**RESPONSES TO U.S. EPA COMMENTS  
ON THE INTEGRATED ENVIRONMENTAL  
MONITORING STATUS REPORT FOR  
SECOND QUARTER 1999**

**FERNALD ENVIRONMENTAL MANAGEMENT PROJECT  
FERNALD, OHIO**

**JANUARY 2000**

**U.S. DEPARTMENT OF ENERGY**

FIGURE G-25. TOTAL URANIUM IN GROUNDWATER CROSS-SECTION B-B'

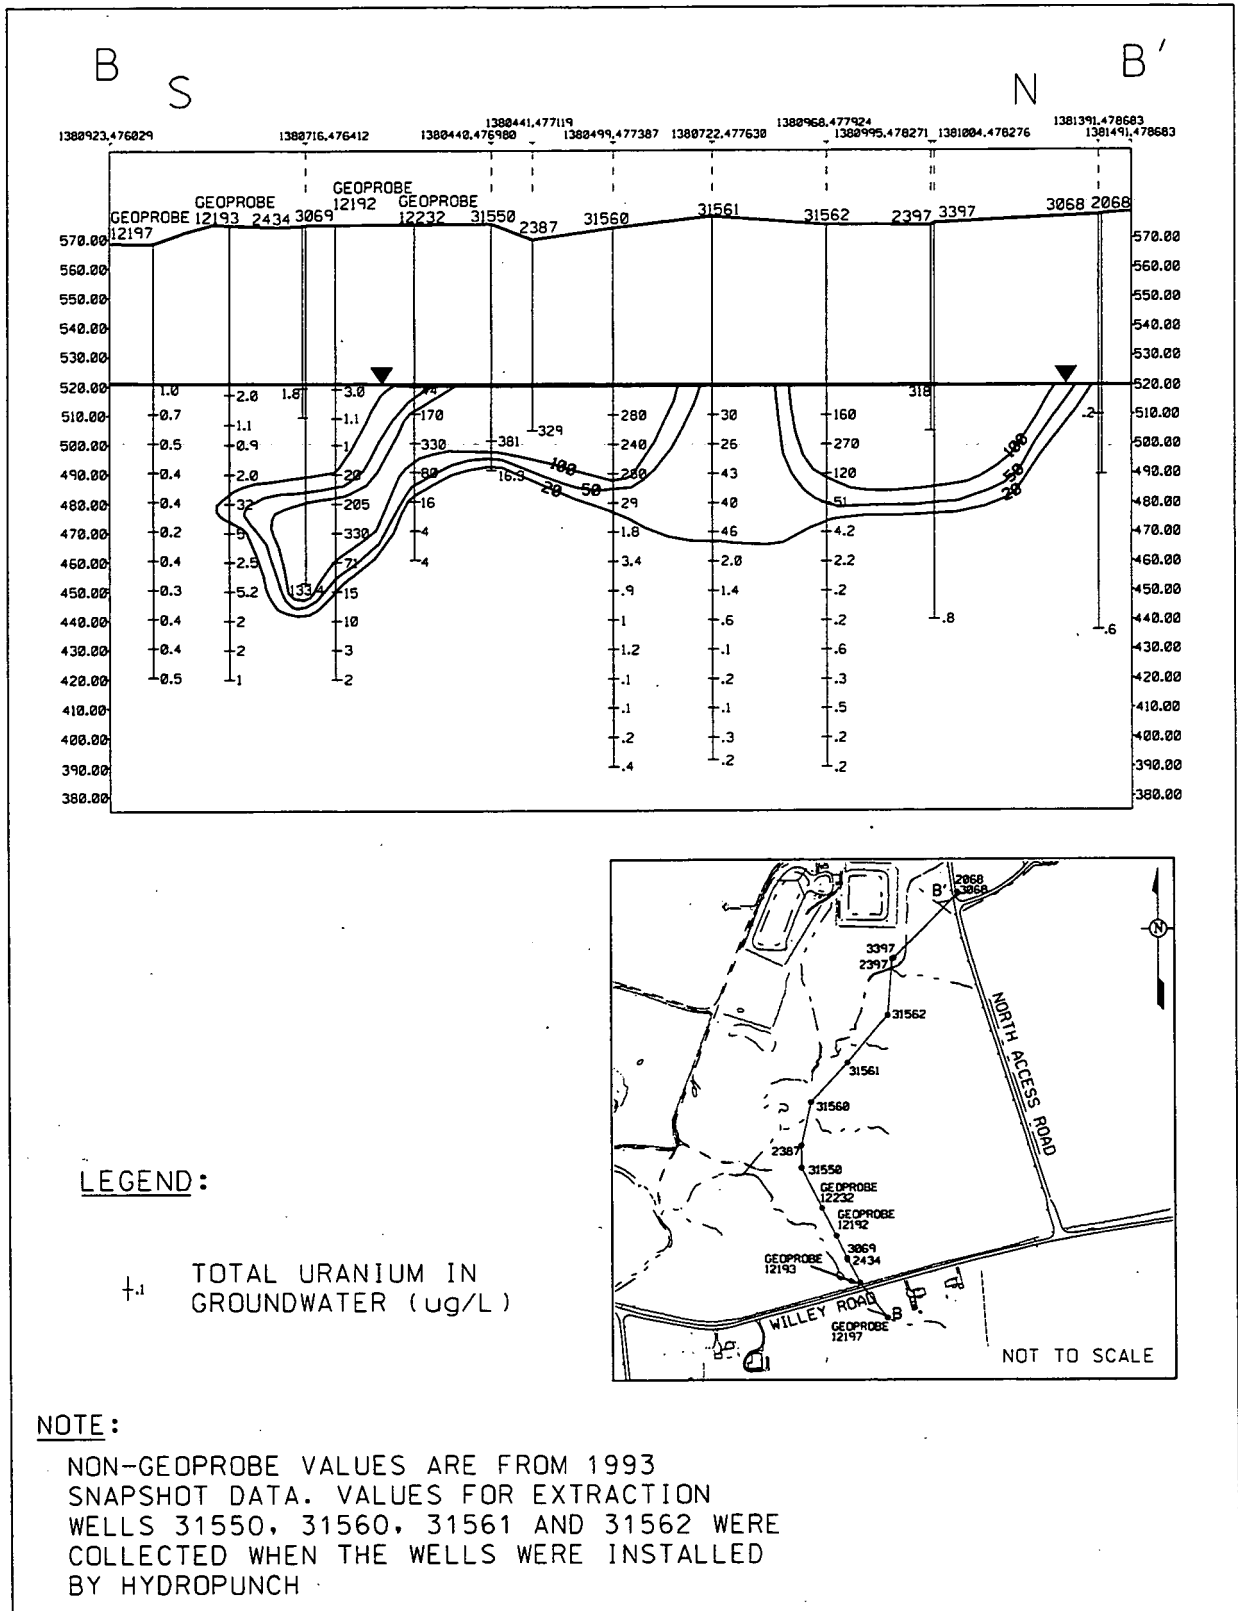
Comment:      The text states that total uranium was detected at location 12408 at a concentration of 184 micrograms per liter ( $\mu\text{g/L}$ ). However, the elevation of this detection is not provided. The elevation at which this sample was collected should be reported. In addition, DOE should evaluate if downgradient monitoring wells 2070, 2398, 2069, 3069, and 21063 are screened at the appropriate depths based on this detection and present the results of this evaluation in the third quarter integrated environmental monitoring status (IEMS) report. It is important to accurately characterize the uranium plume in these areas because the extent of the extraction wells' capture zone is not well defined along the eastern edge of the plume.

- DOE does not currently monitor Monitoring Well 2069 because it has been replaced with property boundary Monitoring Well 2434. Monitoring Well 2434 is currently being sampled quarterly but will be dropped from routine Integrated Environmental Monitoring Plan (IEMP) monitoring beginning in January 2000. The 20  $\mu\text{g/L}$  total uranium plume at this location is deeper than the elevation of the well screens in Monitoring Wells 2069 and 2434. As Cross Section B-B' (Figure G-25), found in Appendix G of the

Baseline Remedial Strategy Report illustrates, the plume at Monitoring Well Cluster 069 is found at the Type 3 well screen depth. The well screen in Monitoring Well 3069 is positioned appropriately. Cross Section B-B' is also attached to this comment response document (Attachment 1).
